Chapel Hill Crossing

Applicant drawings dated 08-03-23

Design Comments

09-22-23

Diagram 1

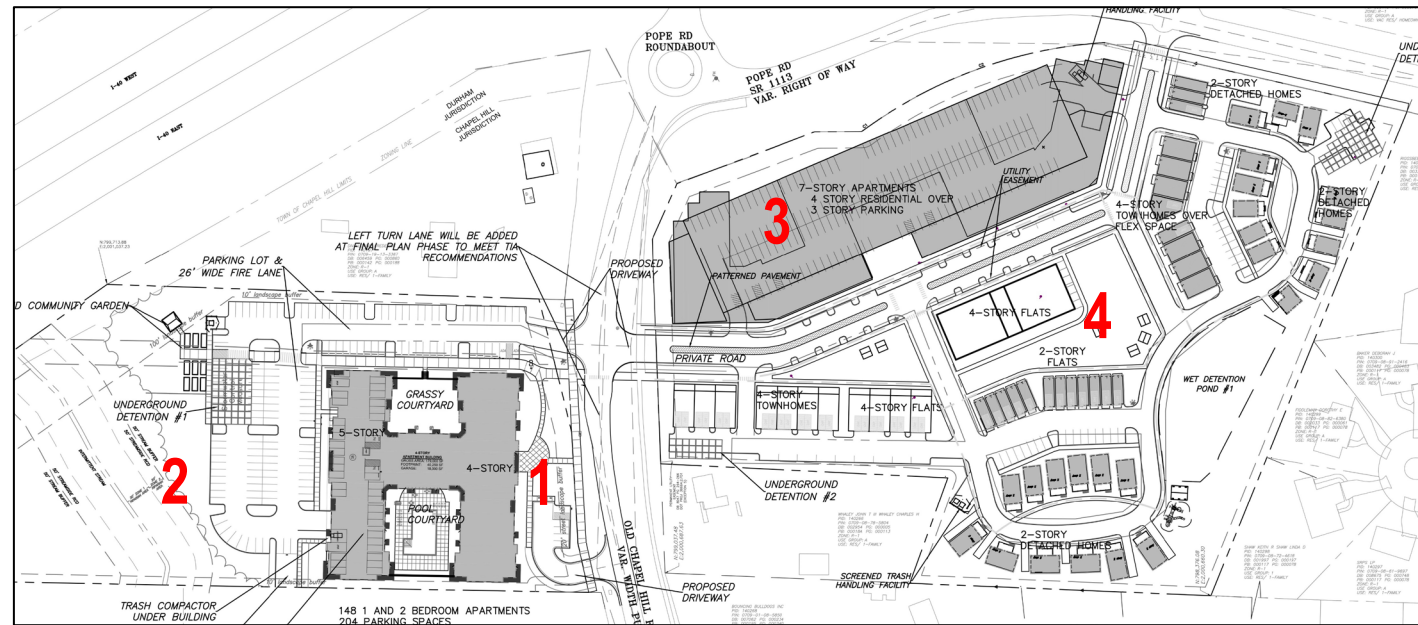
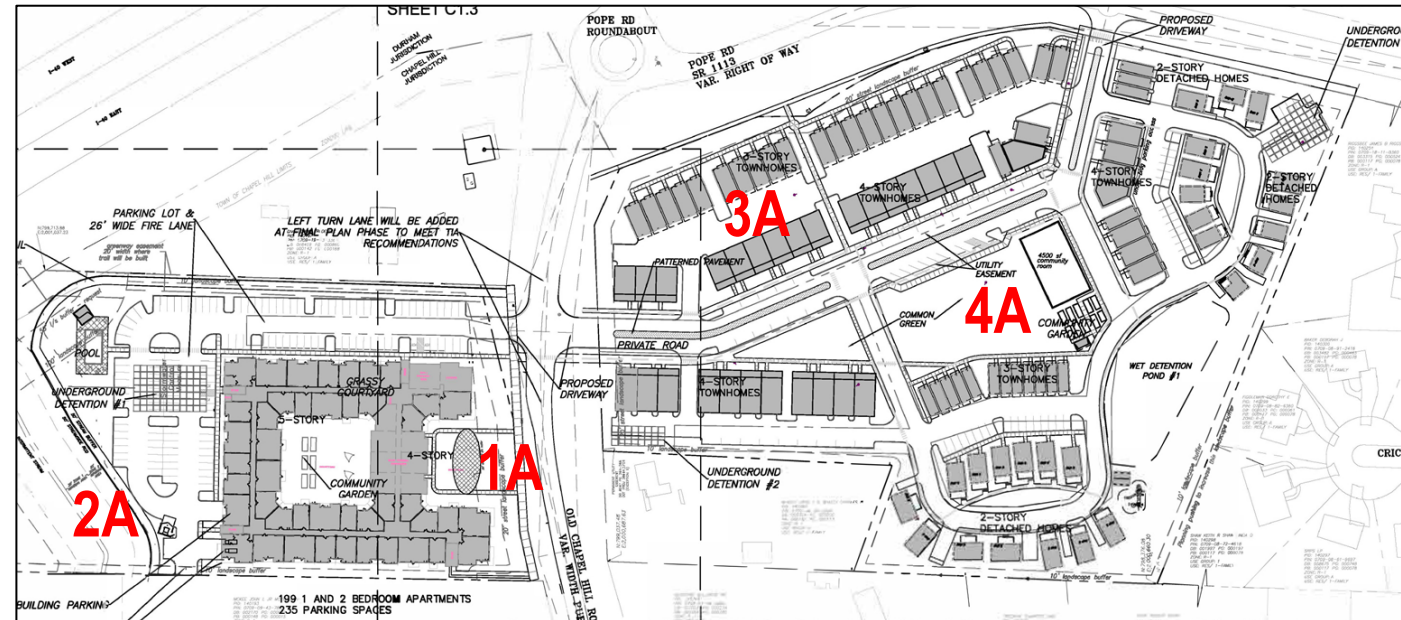
1. Suggested rotating the building so that the courtyard faces the street, allowing the “wings” to present themselves along the street frontage, with the main building mass set further back. Additionally, consider stepping down the building mass along the street frontage, with higher mass toward the back. Make the Old Chapel Hill Road frontage of the building more pedestrian-friendly by eliminating or reducing the drive area in front of the building.

2. Provide a trail along the southern edge of the RCD area. This trail will someday connect to the west, through adjoining properties as they redevelop, eventually extending into the Parkline site.

3. Work to reduce the height and mass of the multifamily building. Consider breaking up the building into separate structures, possibly with the parking floors, if necessary, connected by bridges between the buildings.

- 3A. The large multi-family building has been replaced by townhouses, a significant improvement.
4. Create a more contiguous and spacious open space at the center of the development.

- 1A. The building has been rotated as suggested, and the building height steps down at the end of the wings along the Old Chapel Hill Road frontage. The drive area in front of the building has been eliminated and replaced by a plaza and gathering space.

- 2A. The trail has been provided. A stub out has also been provided that would link to a future service lane, which would extend along the east side of the adjoining property, and eventually connecting into “Street A” of the neighboring Gateway development. Both the greenway connection and the future service lane concept arose from the developer workshops that were held in the summer of 2022, which resulted in the Parkline East Village Development Framework.

- 4A. The four-story flats building, which was previously located in the center of the green space, has been eliminated, allowing the green to be a larger, singular space. A smaller community room building has been provided, at the southern end of the green. Since the overall project no longer features retail uses, this community space has the potential to be designed to offer a mix of activities that might be of interest to those that live in adjoining neighborhoods and become a community hub for the area.
